FIRST DRAFT MINUTES

April 16, 2026, Standards Committee Meeting

RE: Minutes from the April 16, 2026, Standards Committee Meeting

PROPOSED SOLUTION: Update these Standard Drawing series for the current edition of the MUTCD.

E 808-DLIM-02 Dotted Lines for Freeway Acceleration Lanes (shown markups)

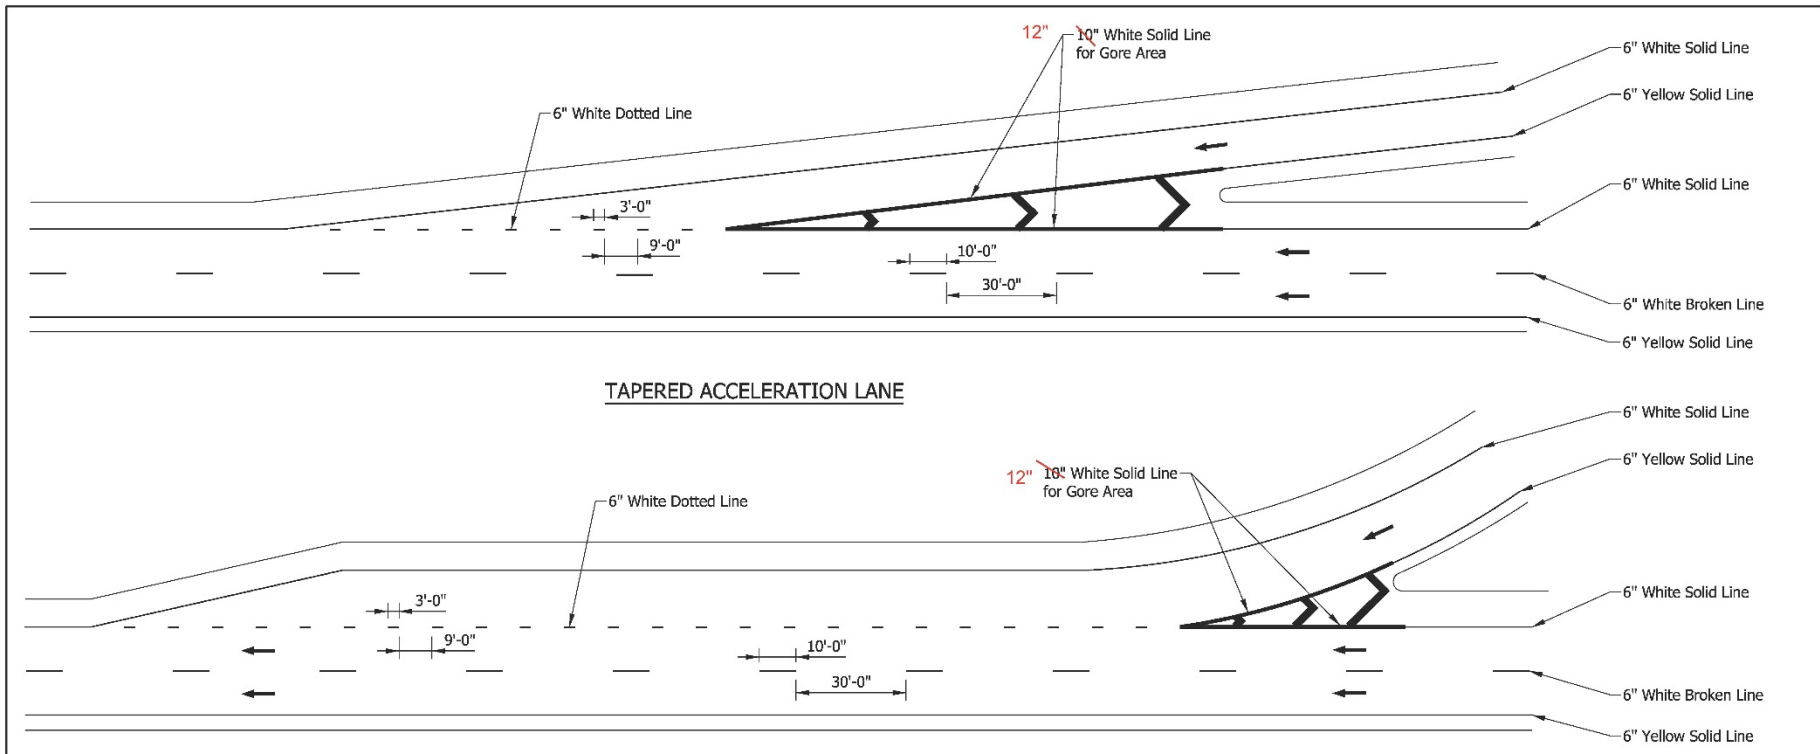
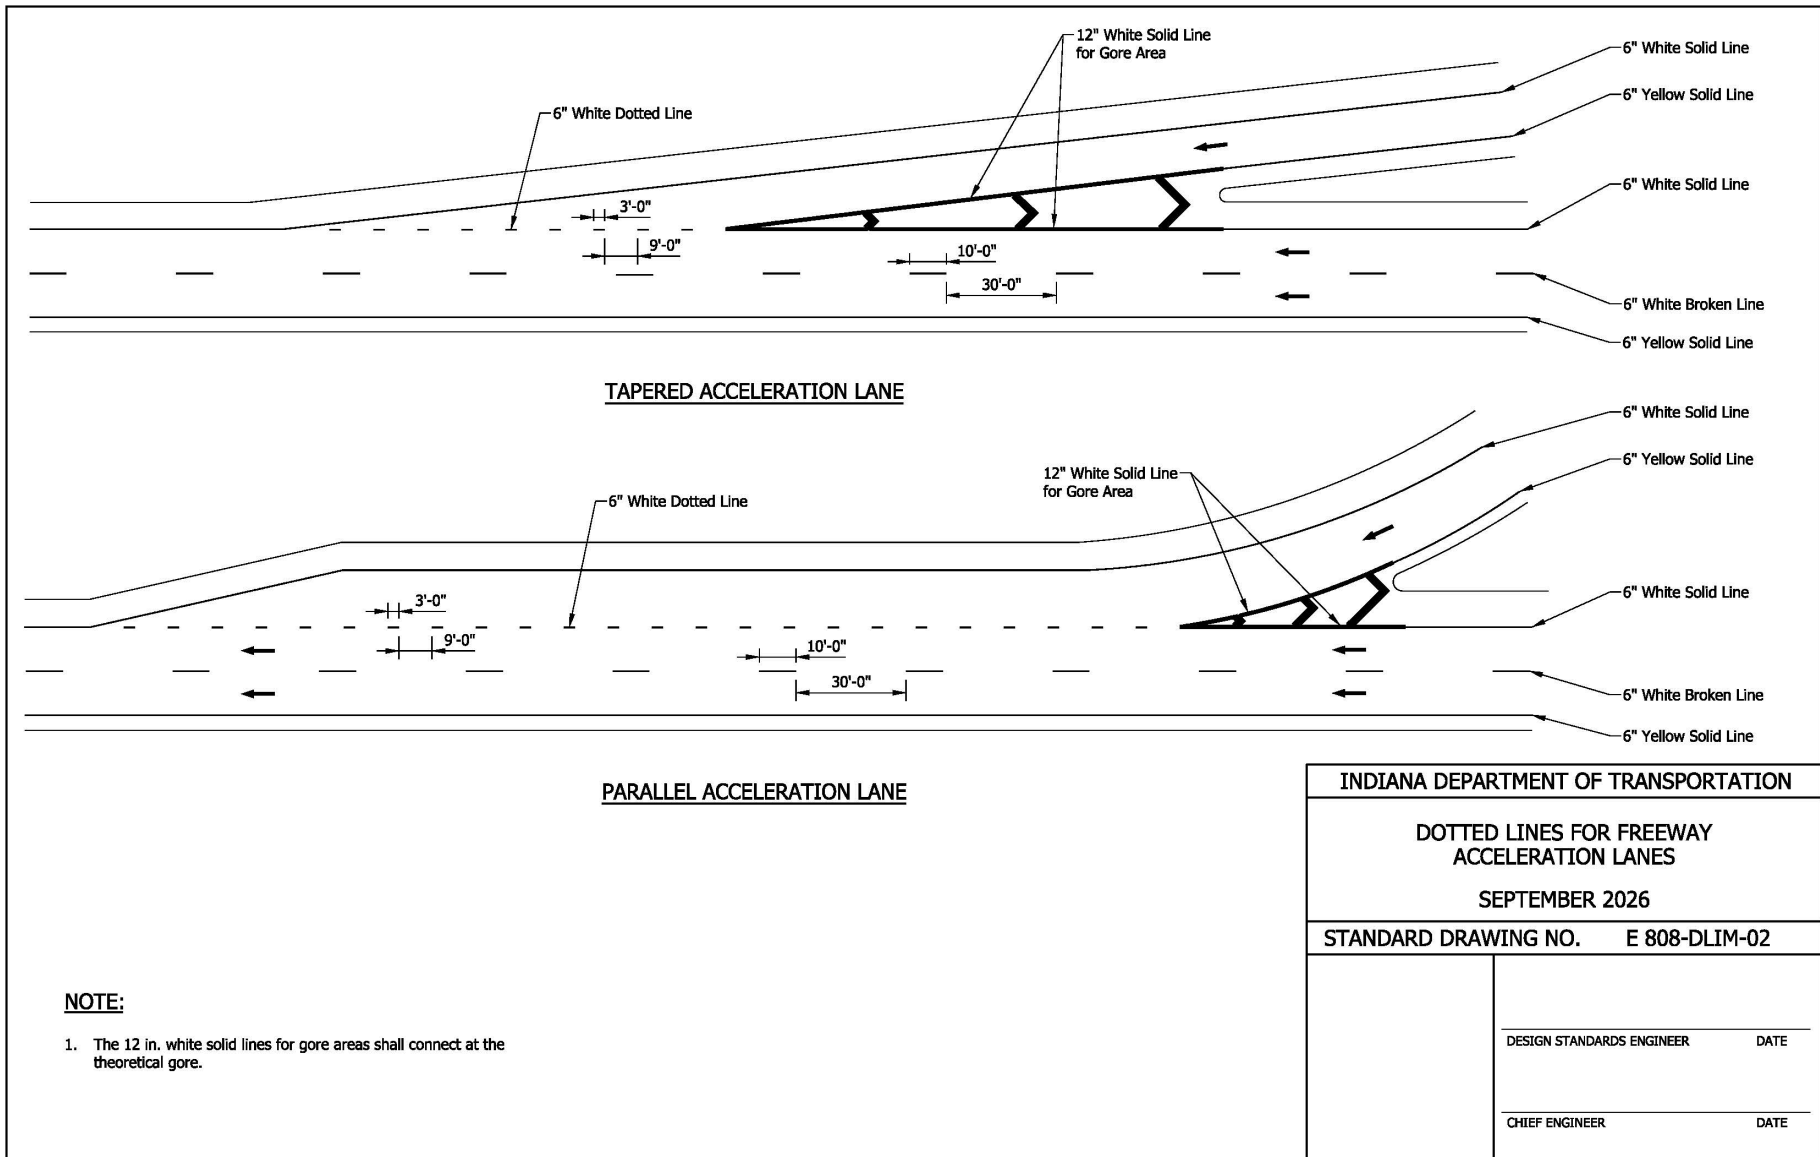
PROBLEM(S) ENCOUNTERED: Section 1B.02 of the 11th edition of the MUTCD requires states to update standard drawings to be in substantial conformance with the MUTCD. The 808-DLIM Standard Drawing series need various minor updates for the current edition of the MUTCD and the table in Standard Drawing 808-MKPM-06 needs to be updated for the current edition of the MUTCD.

E 808-MKPM-06 Transverse Markings Railroad Crossings (proposed draft)

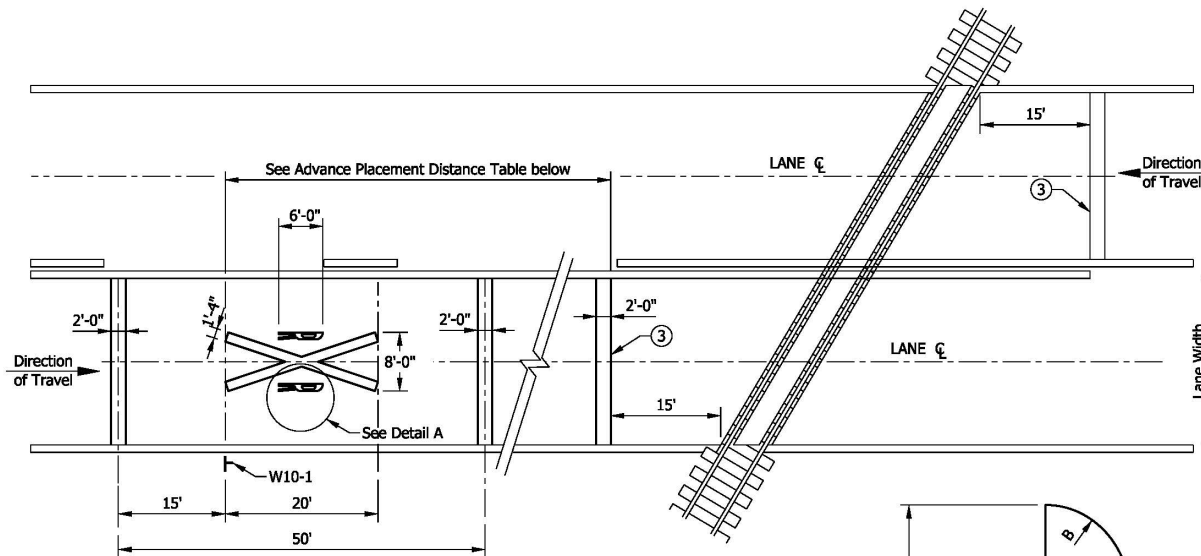
Mr. Koch stated that it seems Note #3 on sheet E 808-MKPM-06 could be problematic. I believe the Advanced Placement Table was created by INDOT based on the MUTCD. Yet changes could happen that go unnoticed. Should we remain silent and strike note #3 as we do not otherwise note each drawing with 'in accordance with the MUTCD'? Mr. Koch clarified that he is an engineer, not a lawyer.
